North Dakota Department of Transportation

ADDENDUM 1 – JOB 43

TO: All prospective bidders on project IM-8-029(170)033, Job No. 43 scheduled for the November 17, 2017 bid opening.

ADDENDUM 1 JOB 43

I-29 - N of Galchutt Exit to Christine Exit
 Plan & Profile
 Colfax Interchange Southeast Ramp Connection
 Sta 100+00 to 115+76 (RC_37_N_SER)

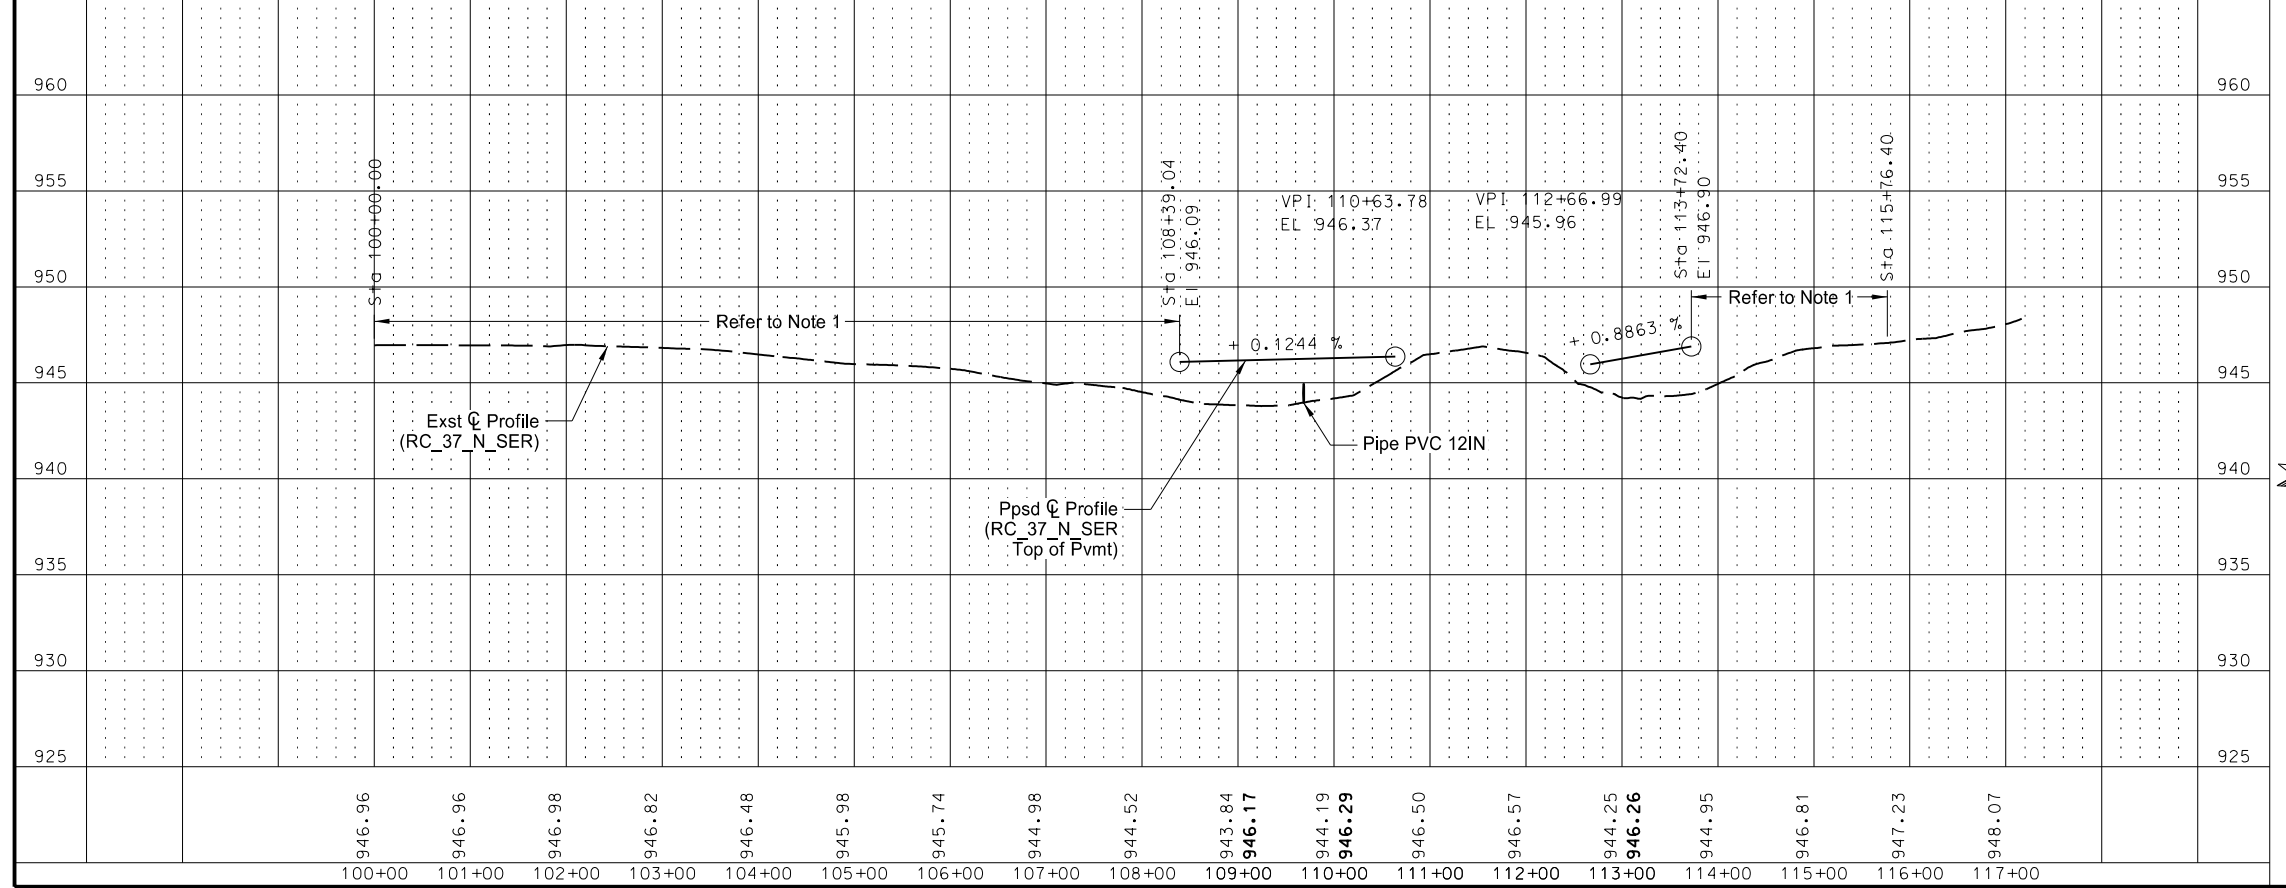
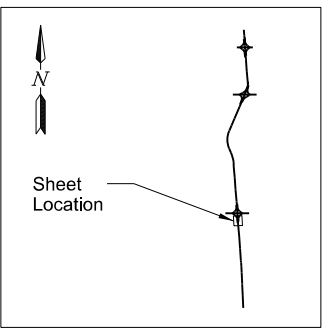
- Revised bid item quantities so “714-9640 RELAY PIPE-ALL TYPES & SIZES” represents the PVC pipe remove and relay quantities.

SPEC	CODE	BID ITEM	QTY	UNIT
714	9640	RELAY PIPE-ALL TYPES & SIZES		
Sta 108+55 ~ 21.7' Rt to Sta 110+75 ~ 29.6' Lt			226	LF

Revised 9/21/2017	STATE	PROJECT NUMBER	SECTION NO.	SHEET NO.
	ND	IM-8-029(170)033	170	23A

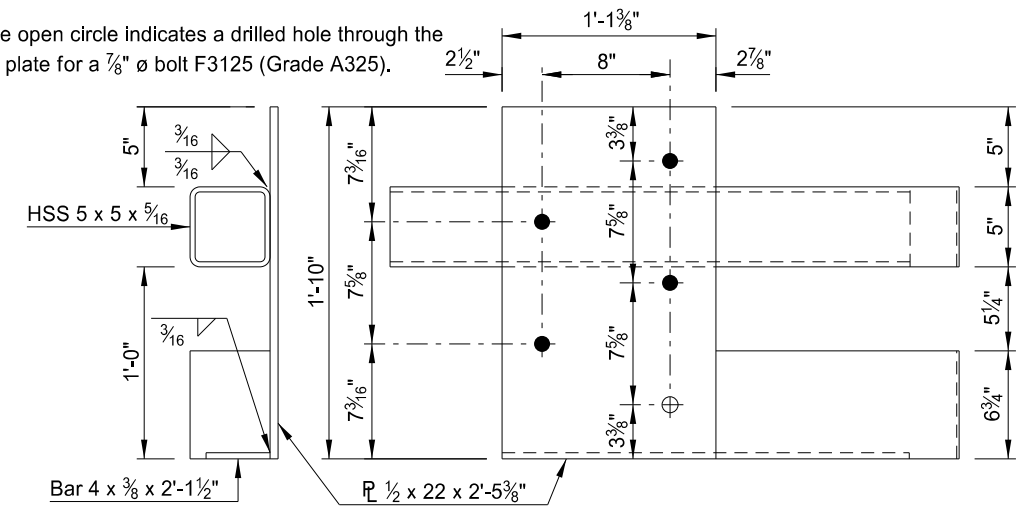
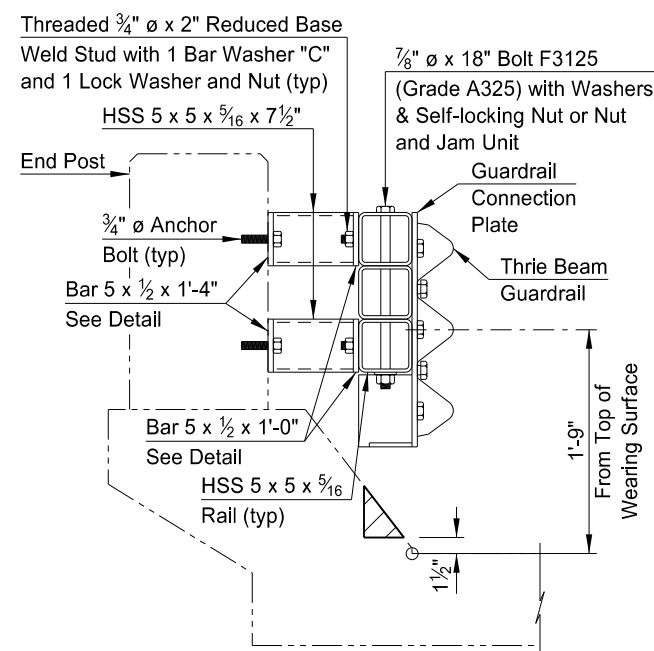
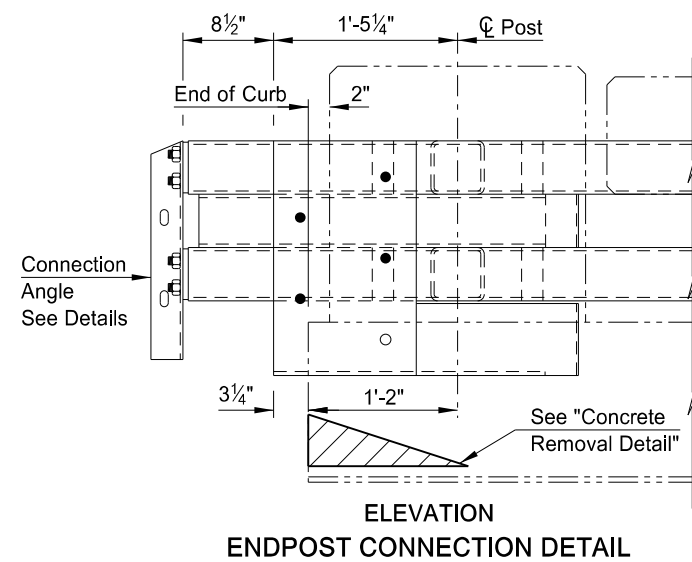
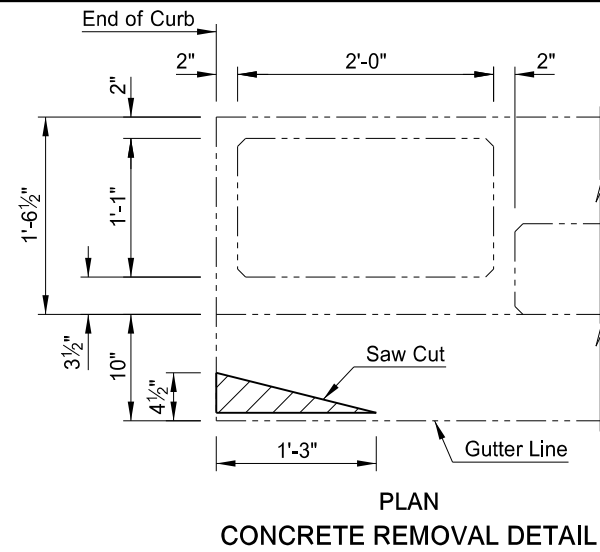
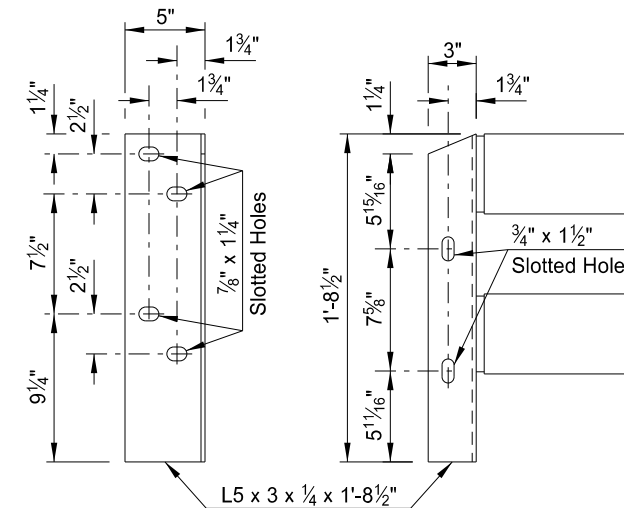
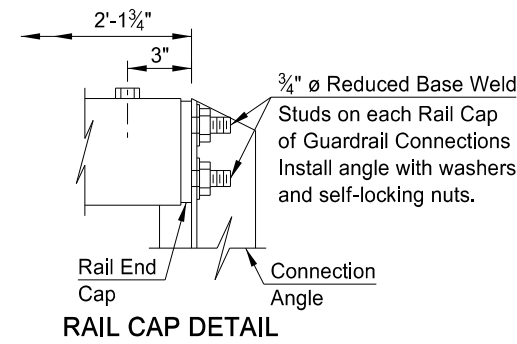
- Sheet added for connection plate modification details.

Revised 9/21/2017	STATE	PROJECT NUMBER	SECTION NO.	SHEET NO.
	ND	IM-8-029(170)033	170	27

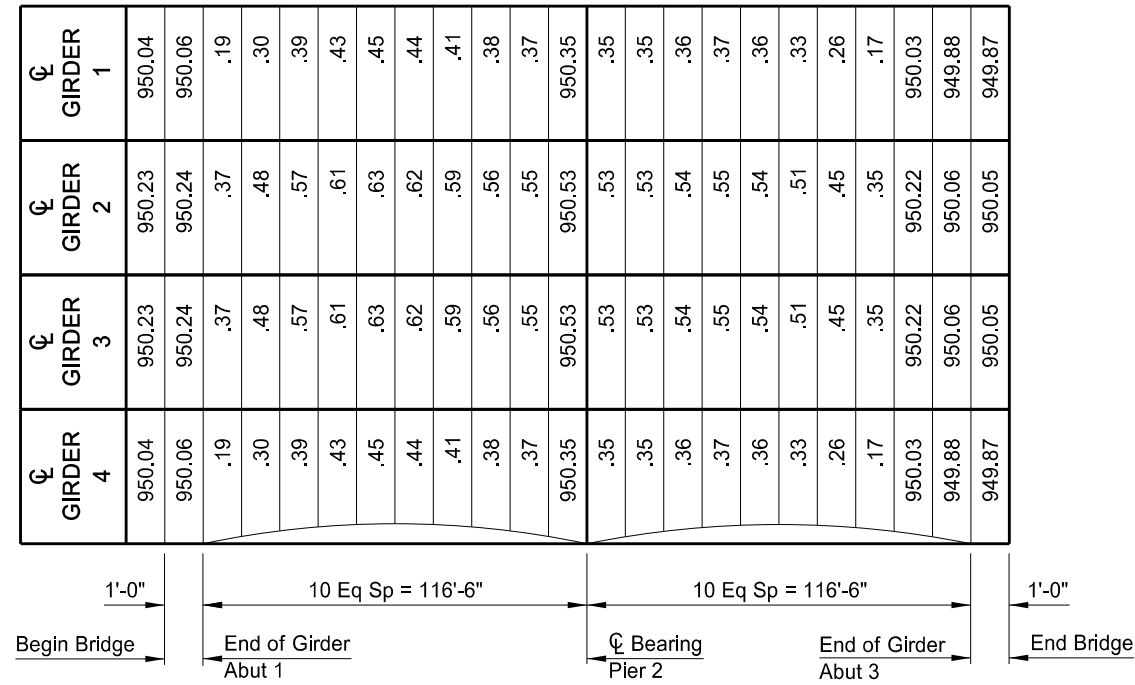
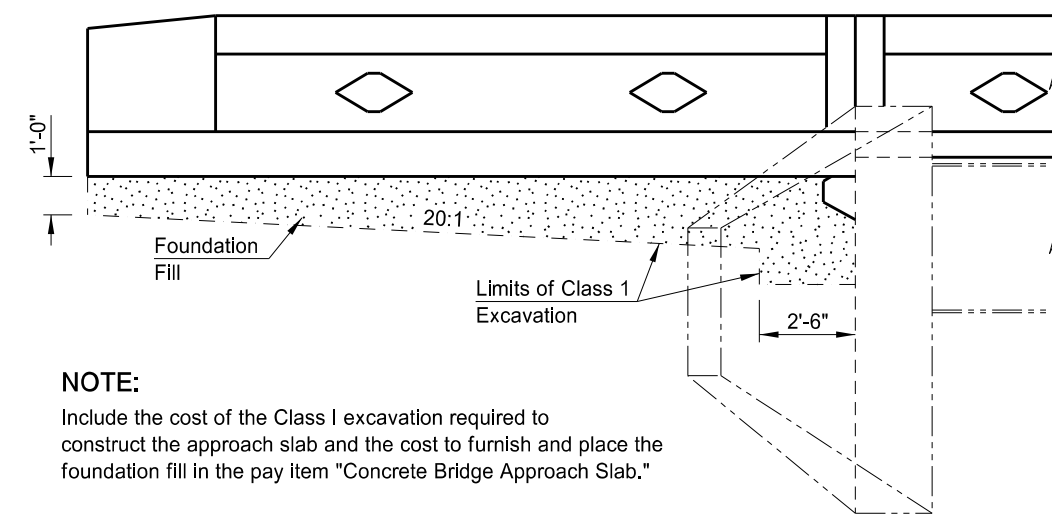
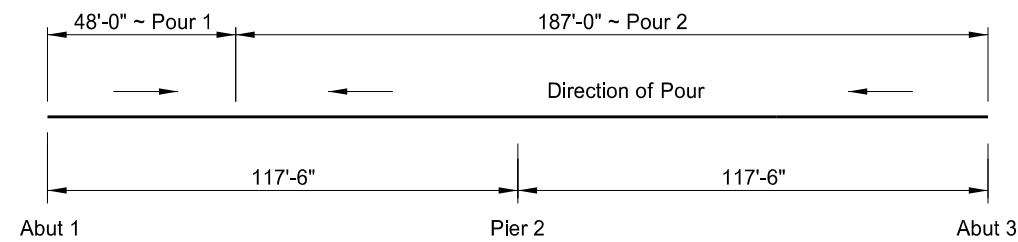
- Updated 612-0116 Reinforcing Steel - Grade 60 - Epoxy Coated quantity.

Revised 9/21/2017	STATE	PROJECT NUMBER	SECTION NO.	SHEET NO.
	ND	IM-8-029(170)033	170	31

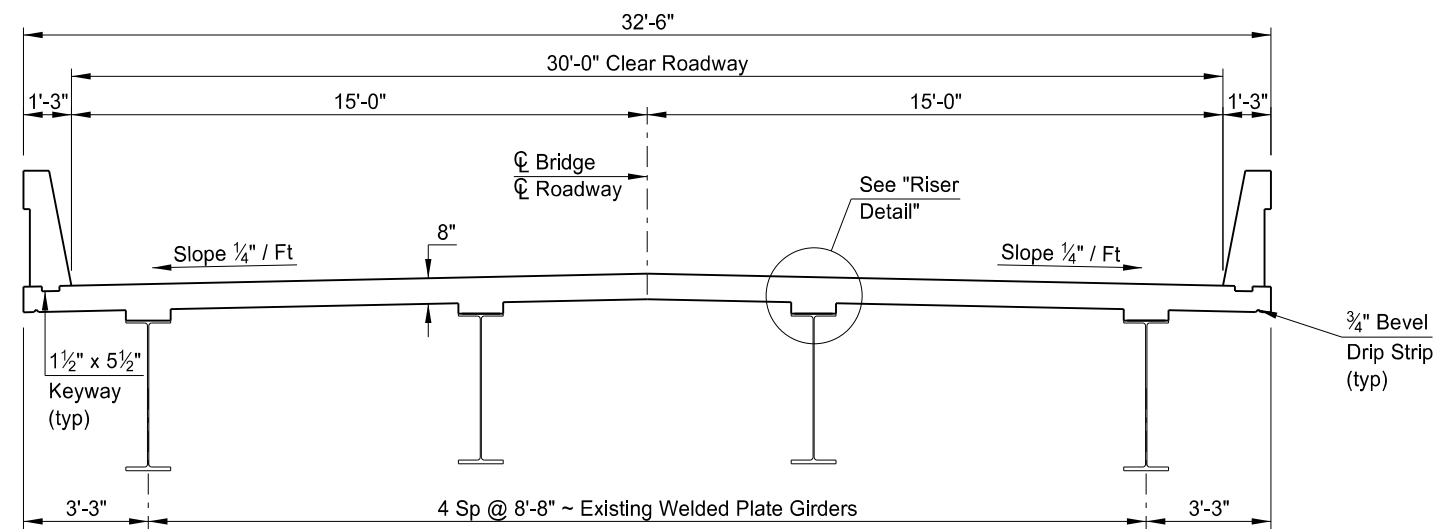
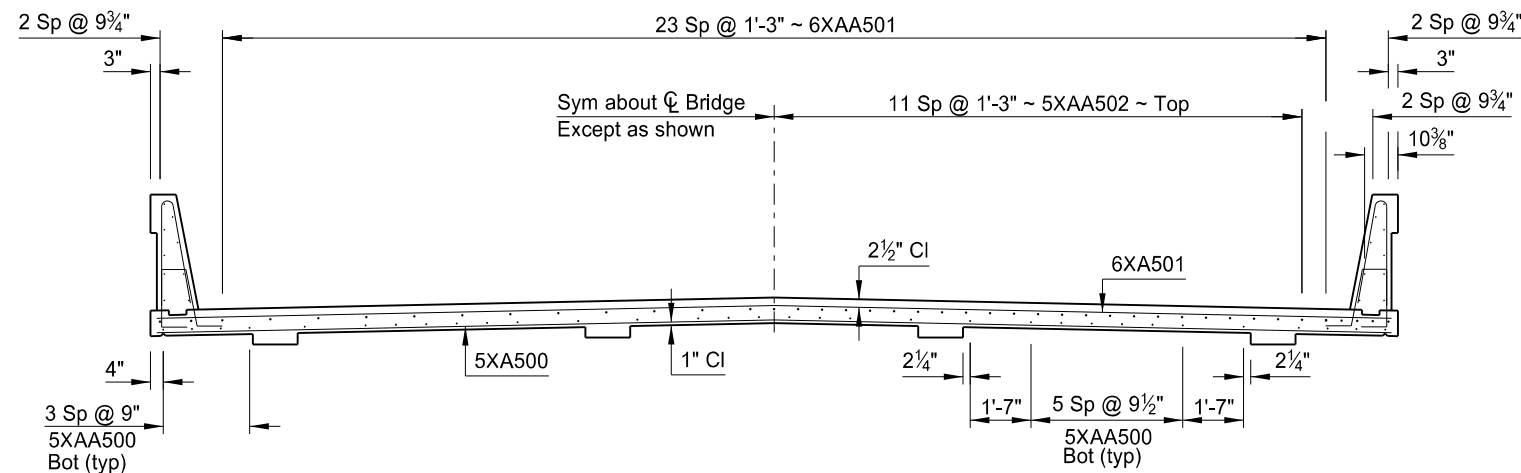
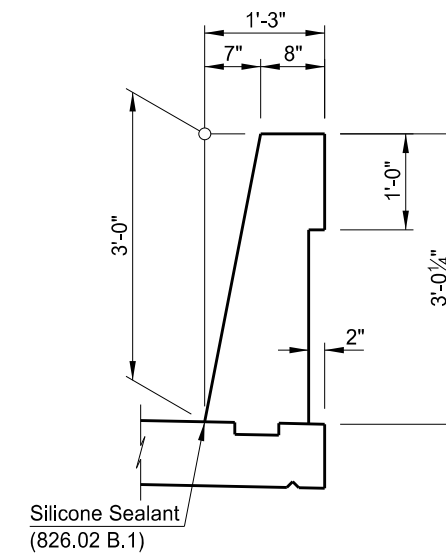
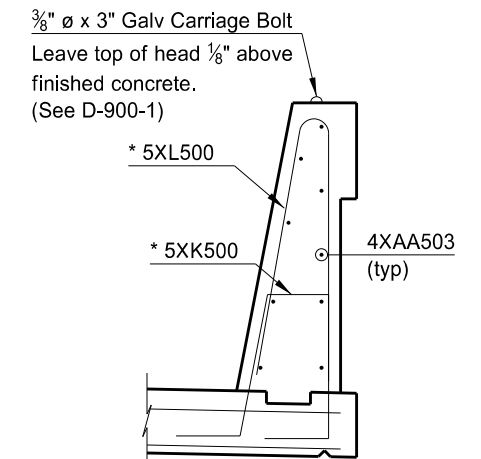
- Updated Reinforcing Steel (Epoxy) Quantity.

QUANTITIES	
CLASS AAE-3 CONCRETE	269.6 CY
REINFORCING STEEL	1,204 LBS
REINFORCING STEEL (EPOXY)	68,747 LBS
